From: ELST Master Plan <ELST@kingcounty.gov>
Sent: Thursday, January 26, 2017 10:29 AM
To: reddy@benefits-consulting.com
Cc: Lindsey Ozbolt; MikeSch@msn.com
Subject: 170126 ELST South Samm B - Reddy - ROW
Attachments: 170126 ELST South Samm B - Reddy - ROW.pdf

east lake sammamish trail

RE: King County SSDP Permit-- South Sammamish Segment B
Homeowner comments regarding 60% Design Plan
Survey Station 332+00
2221 East Lake Sammamish PL SE

Subject: East Lake Sammamish Trail Expansion and Impact Questions regarding the proposed 60% plan for South Sammamish B Segment. To be included in the public record as documented concerns against the King County trial permit application.

Wall #6 Wall Profile

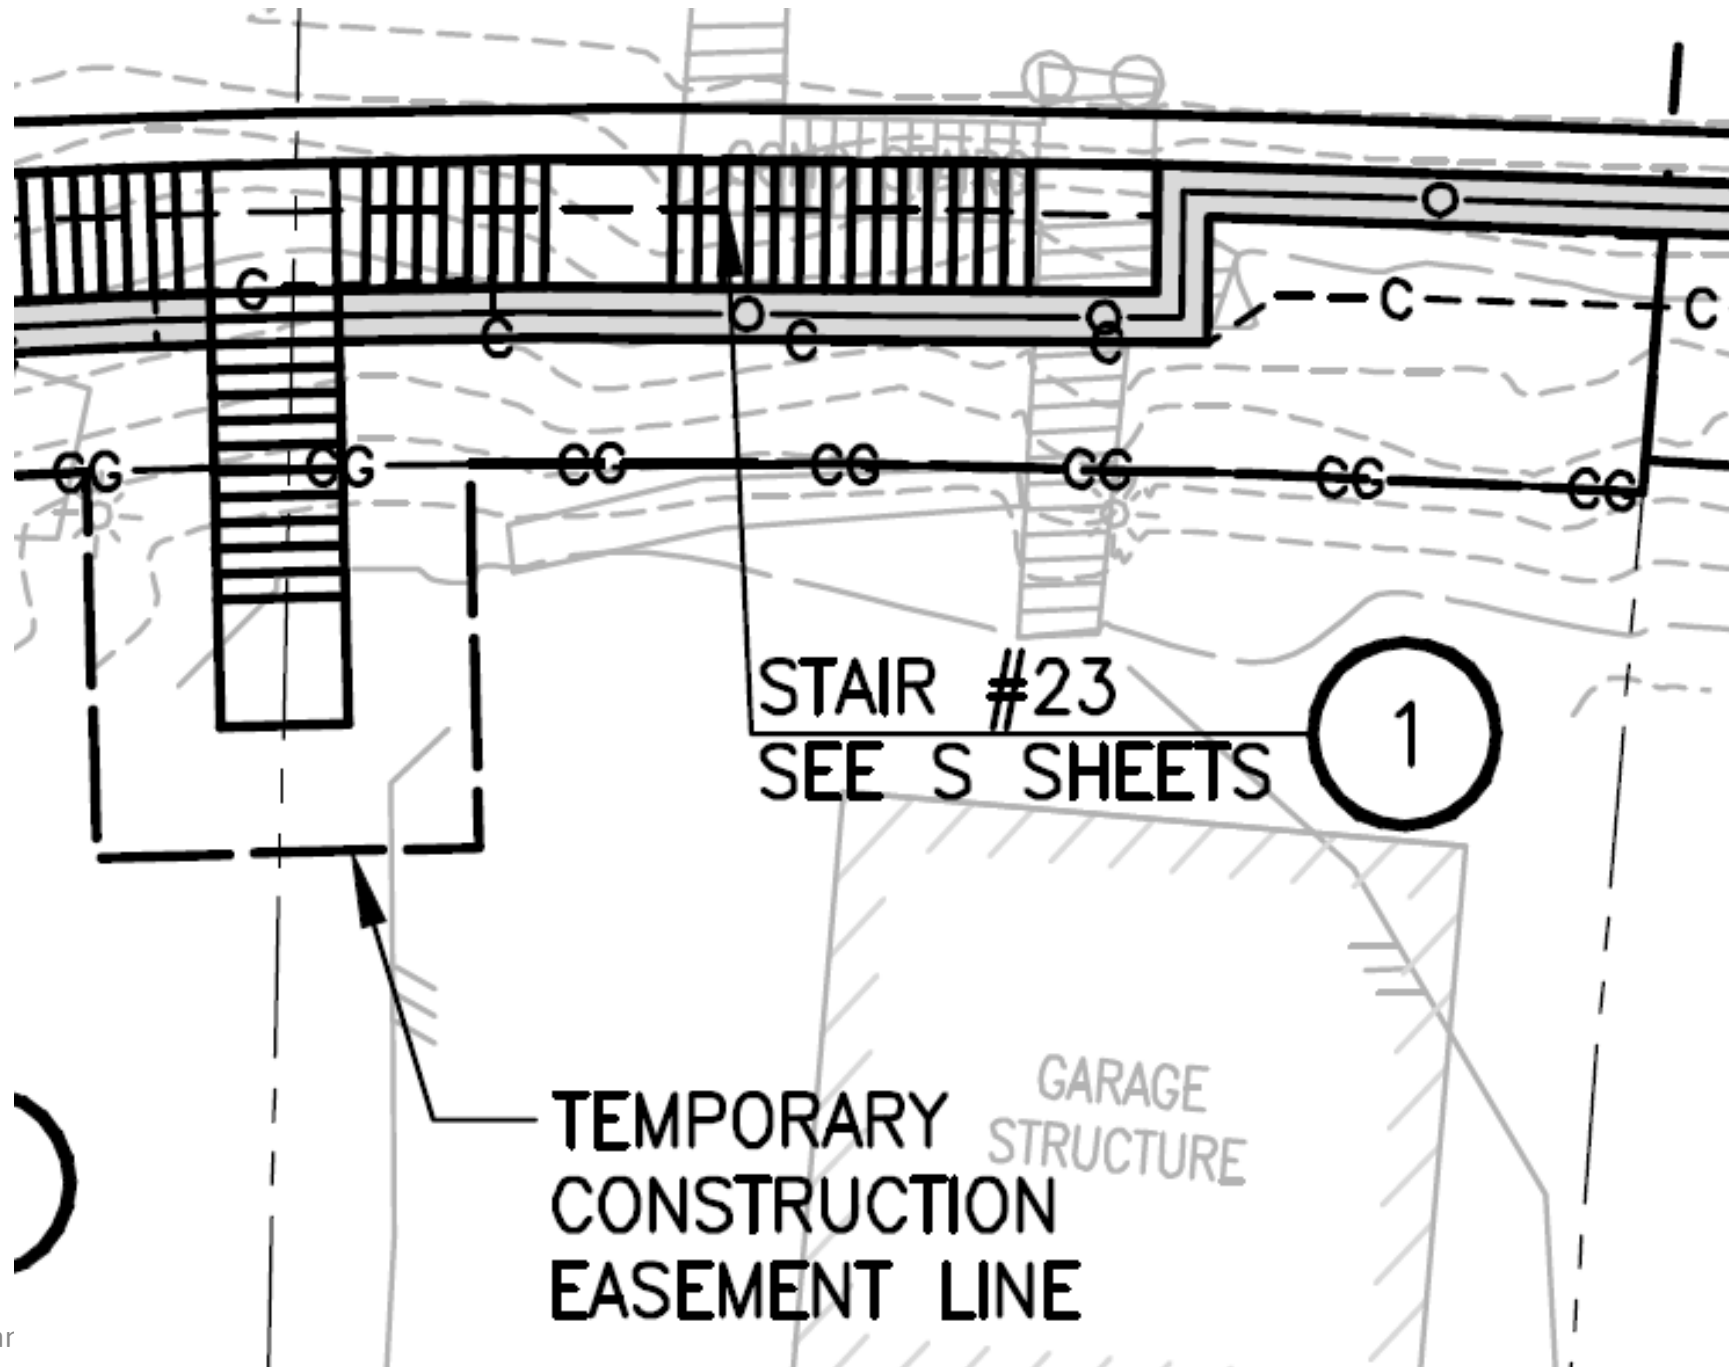
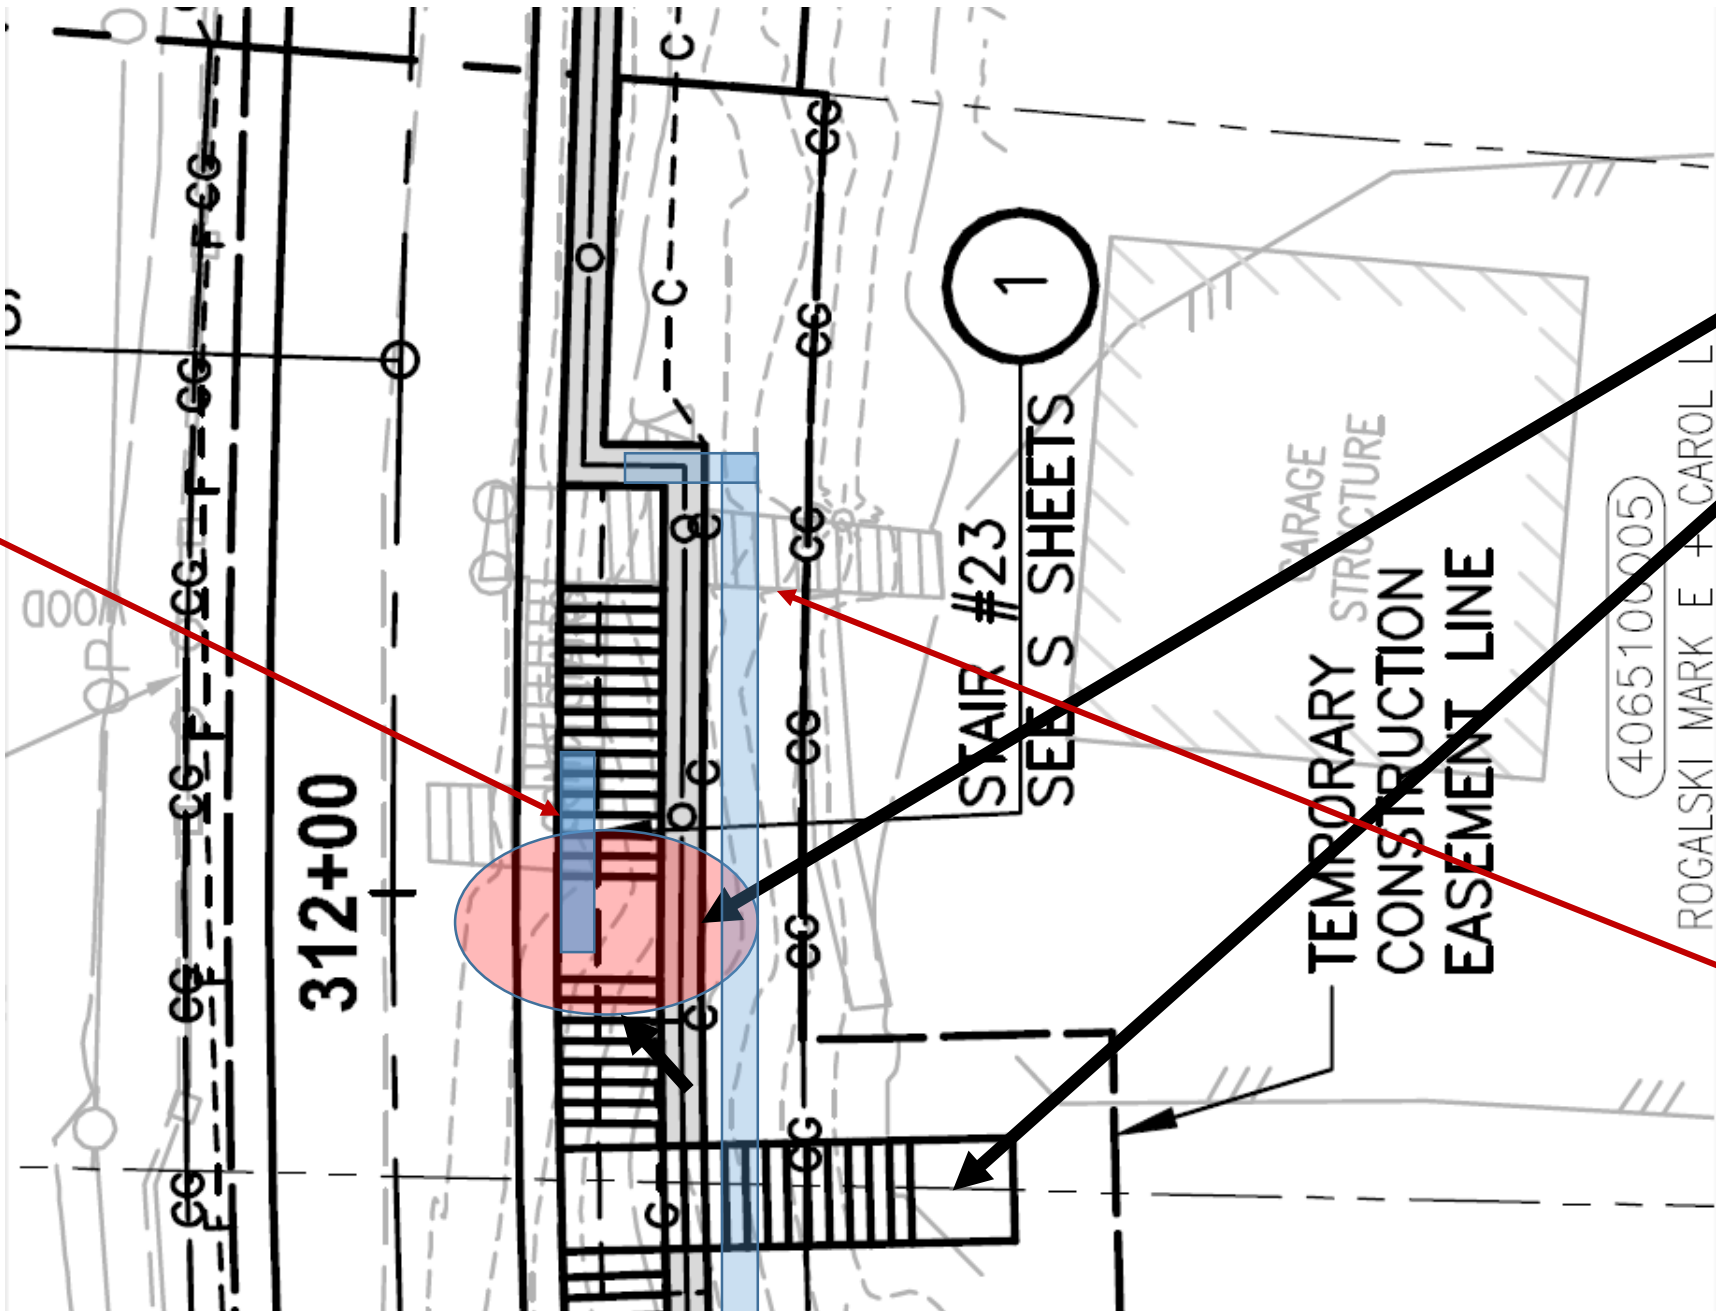
62-64 ft line and area for Reinhardsen

70 - 74 ft line and area for Rogalski

Support footing with pillar attach anchors in front of wall to attach pillars to support overpass. (option concept)

Sheet 108 of 135 (East Lake Sammamish Master Plan trail South Sammamish Segment B 60% review

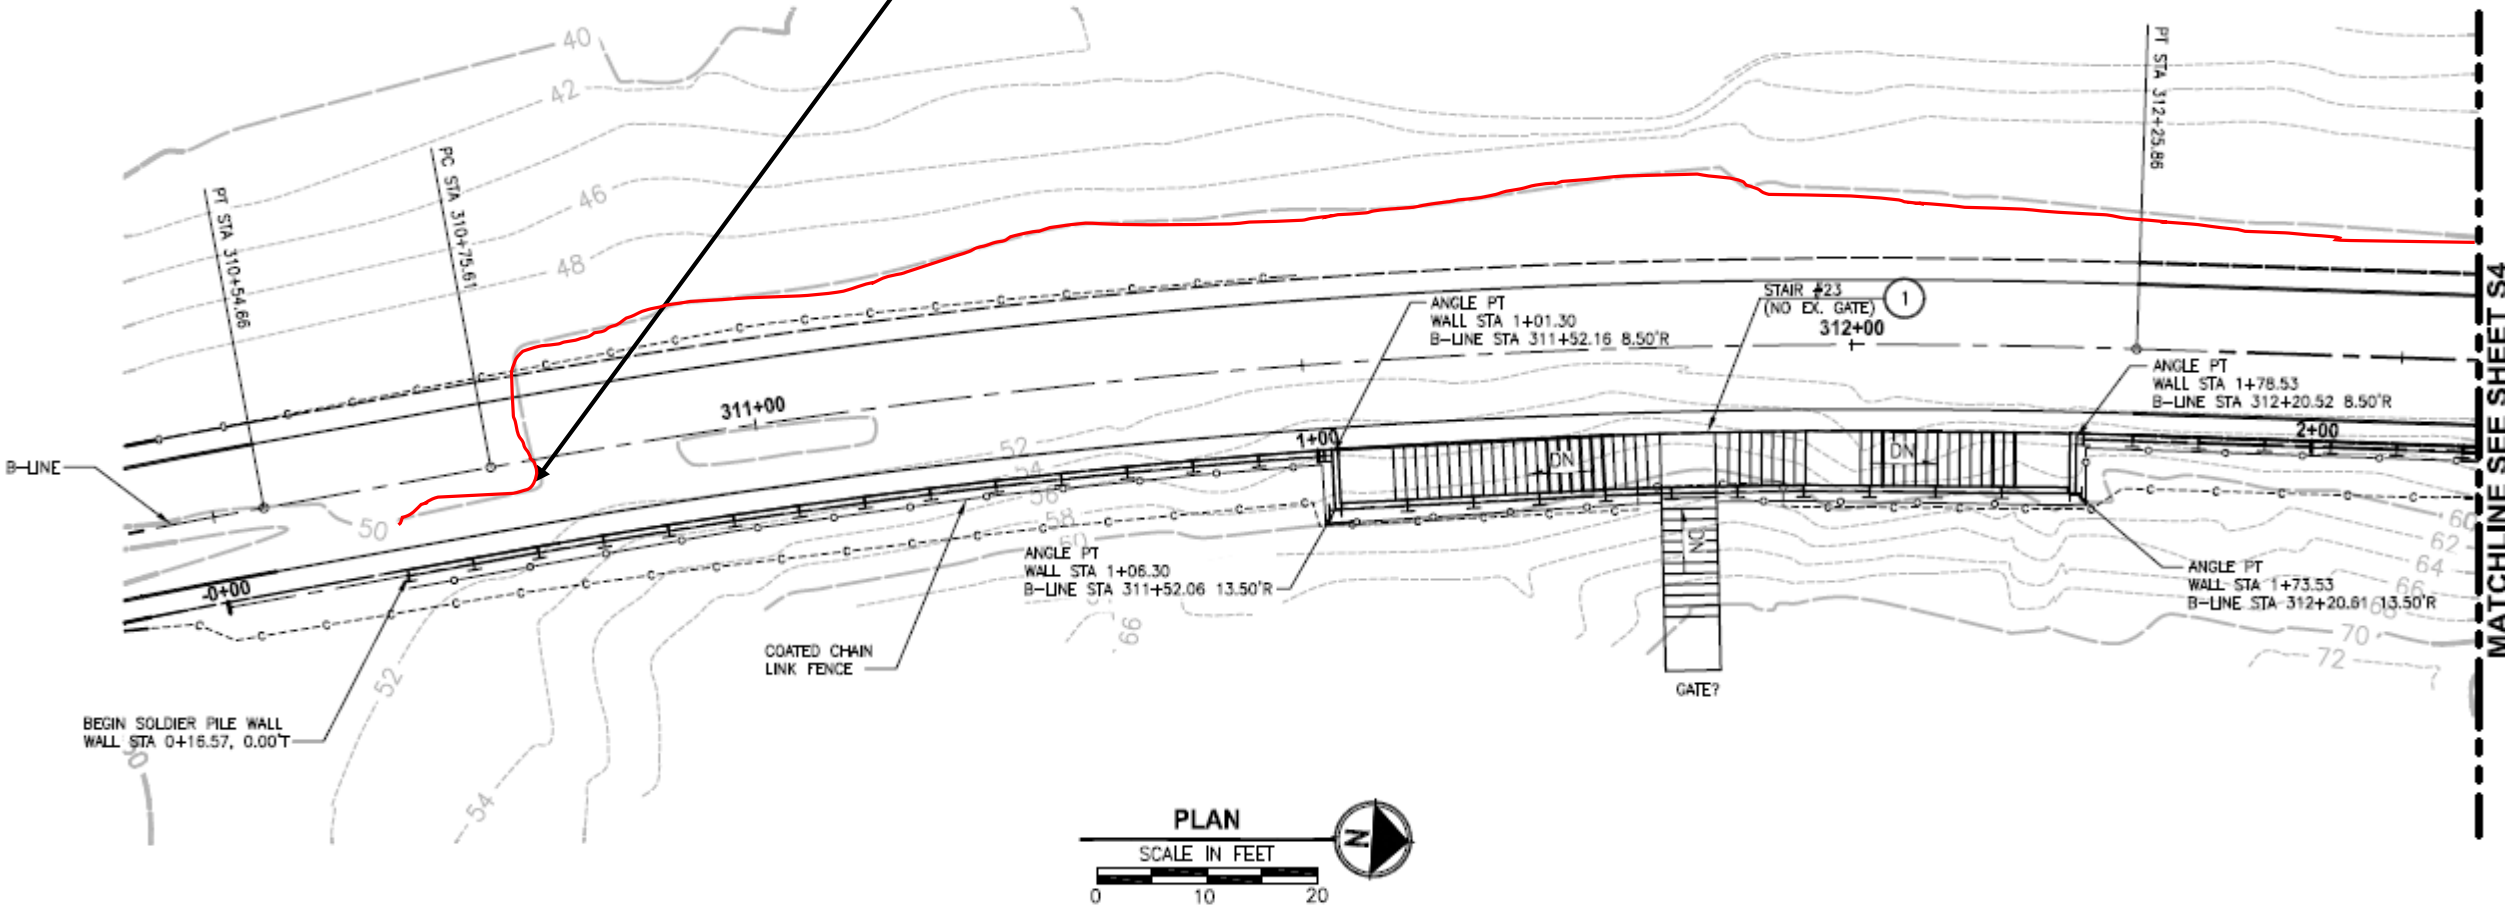
Elevations are not consistent with previous Surveys. Easement elevation is at 46- 47 feet and not at 50 feet as shown on these plans. Center line of Easement is at 46.9 Ft.

Elevations are not consistent with previous Surveys. Easement elevation is at 46- 47 feet and not at 50 feet as shown on these plans. Center line of Easement is at 46.9 Ft. Needs correction to assure elevations are consistent with current grade within reason of conversion to a trail. Plans for bridge are relative to existing trail/Grade height. Correct/reconcile elevations and provide drainage plan.
